KEY TECHNICAL ISSUE

UNSATURATED & SATURATED FLOW UNDER ISOTHERMAL CONDITIONS

NRC/DOE TECHNICAL EXCHANGE PRE-LICENSING ISSUE RESOLUTION APRIL 25-26, 2000 LAS VEGAS, NV

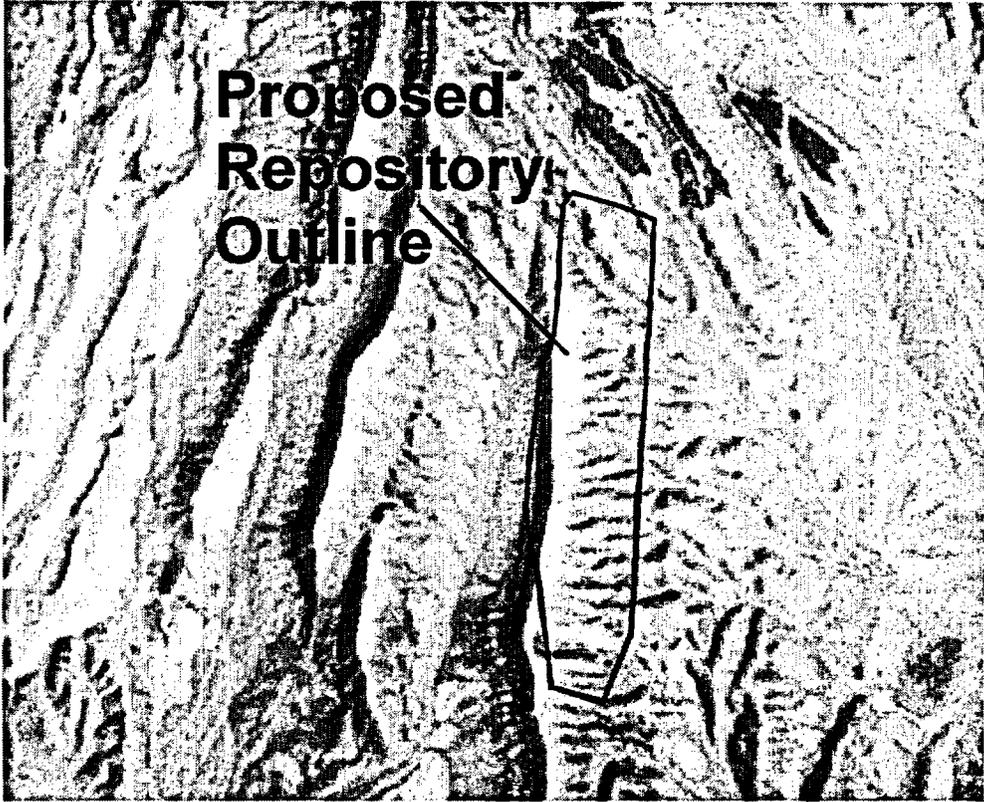
Seepage into drifts has a potentially large effect on repository performance because it controls the amounts of water that can contact drip shields and waste packages
